Regional Review Finding Development of Regional Impact

RE: Development of Regional Impact (DRI) Review

Name of Proposal: TD Jakes - Fort Mac Village One DRI 4370

Description: *A DRI review of a proposal to construct a mixed-use project with 191 townhomes, 817 multi-family units (mid-rise apartments), 84 senior adult multifamily units, a 270 room hotel, 60,675 square feet of general office space, 23,625 square feet of medical office space, private charter K-8 school with approximately 500 students, 125,778 square feet of shopping center space include a grocery store, 3,600 square feet of fast casual restaurant space, and 3,500 square feet of fast-food restaurant space on a 96-acre site within the former Fort McPherson military base at 1601 Lee Street in the City of Atlanta adjacent to the Oakland City MARTA station.*

DRI SITE PLAN

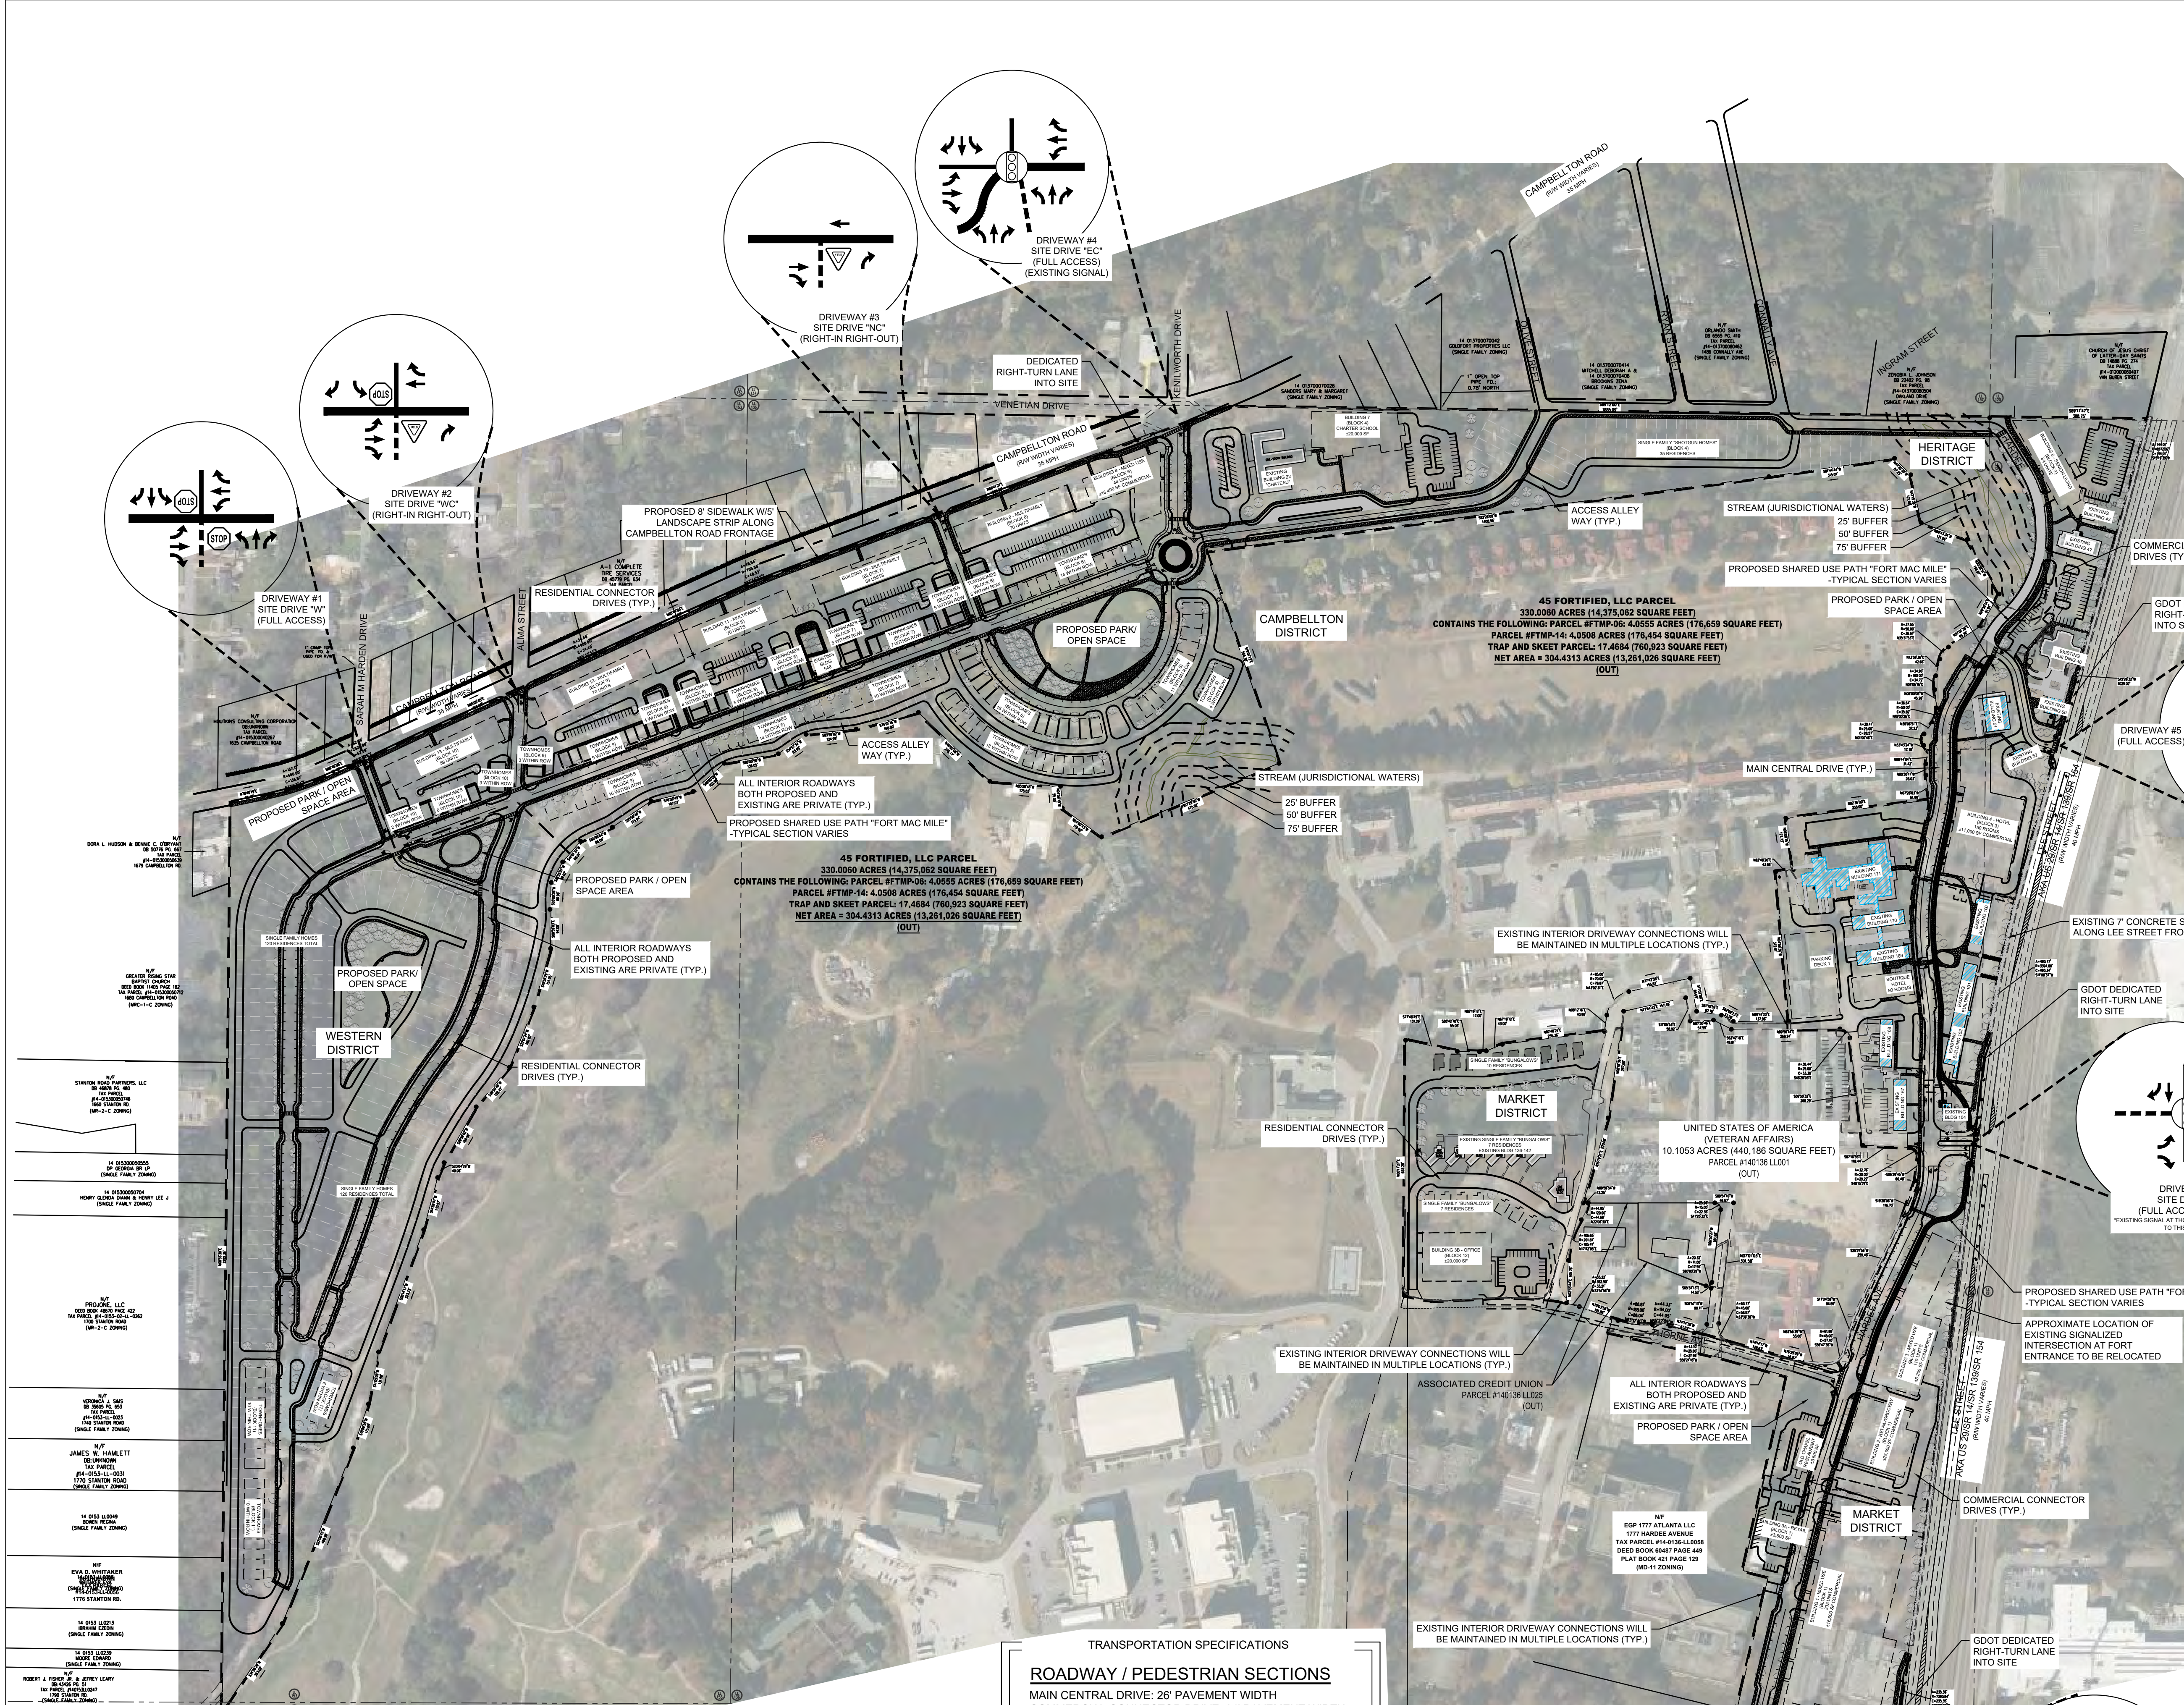
ARC's Natural Resources Group comments are attached. The USGS coverage for the project area shows an intermittent blue-line stream running from a lake on the Fort Mac property to the southwest, but it does not run through the portions of the property included in this project proposal. The project site plan shows a portion of an unmapped stream across a small portion of the project area in the north central portion of the project near Campbellton Road. A 50-foot undisturbed buffer and additional 25-foot impervious setback are shown on both sides of the Creek but should be shown as a 75-foot buffer, as the City buffer requirement has no separate impervious setback. The State 25-foot Sediment and Erosion Control buffer is also shown along the stream. Any other unmapped streams identified on the project property may be subject to the City of Atlanta's stream buffer ordinance. Any unmapped State waters identified on the property will be subject to the State 25-foot Sediment and Erosion Control buffer.

The USGS coverage for the project area shows an intermittent blue-line stream running from a lake on the Fort Mac property to the southwest, but it does not run through the portions of the property included in this project proposal. The project site plan shows a portion of an unmapped stream across a small portion of the project area in the north central portion of the project near Campbellton Road. A 50-foot undisturbed buffer and additional 25-foot impervious setback are shown on both sides of the Creek but should be shown as a 75-foot buffer, as the City buffer requirement has no separate impervious setback. The State 25-foot Sediment and Erosion Control buffer is also shown along the stream. Any other unmapped streams identified on the project property may be subject to the City of Atlanta's stream buffer ordinance. Any unmapped State waters identified on the property will be subject to the State 25-foot Sediment and Erosion Control buffer.
